FAG Service Info

Change of design to protective dust cover

Part replacement - RIU: 566283.H195 replaced with 566283.01.H195

Image 1: The design of the dust-protection cover has been changed

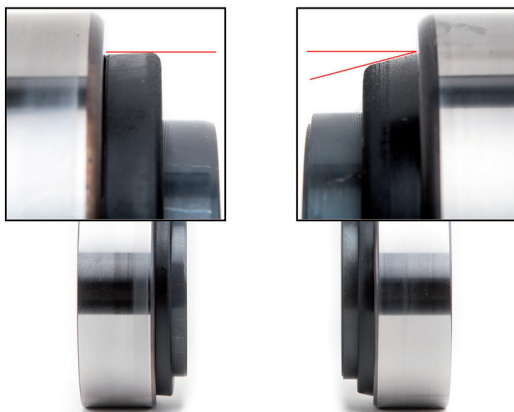
During fitment of Repair Insert Unit (RIU) part number 566283.H195, the protective dust cover may become twisted on some wheel hubs. In the worst case scenario, a twisted protective dust cover may cause a bearing to become obstructed, thereby making it difficult for the wheel hub to turn or prevent it from turning altogether.

For this reason, a modified protective dust cover has been developed (see image 1).

As a result of this technical modification, part number 566283.H195 has been replaced with 566283.01.H195.

On both wheel hubs, measurement and installation testing has been performed successfully using the new RIUs.
